# **CIVIL AVIATION AUTHORITY OF NEW ZEALAND**

## **AIRWORTHINESS DIRECTIVES**

**Amendment Nr 25-08**

**Effective date 28 August 2025**

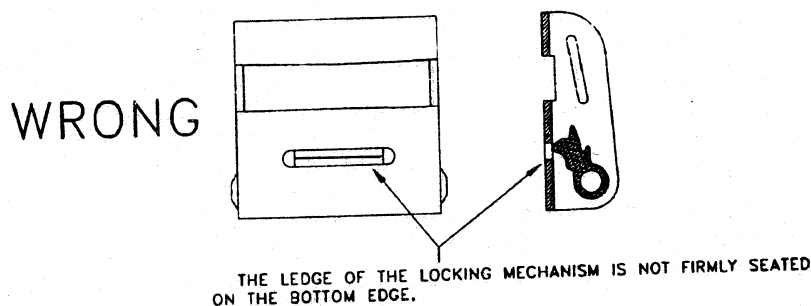
**Requirement:** To prevent failure of the seat restraint system due to the buckle assembly locking mechanism not engaging properly, which could result in the restraint system failing to properly secure the occupant during turbulence or landing, accomplish the following:

After the lever is completely closed, examine the slot in the bottom of the buckle. The locking mechanism should be firmly seated against the edge of the slot as shown in Figure 1.

If the locking mechanism does not seat properly, replace the buckle with an airworthy buckle.

**DCA/BRAKE/5 Tailwheel Fork - Inspection**

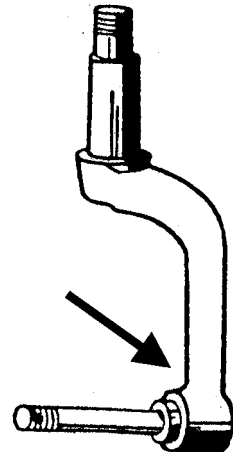
**Requirement:** To prevent fatigue failure of the tailwheel fork, remove the wheel from the axle and perform a dye-penetrant inspection of the fork for cracks. Particular attention is required in the area indicated. Replace any forks found cracked before further flight.
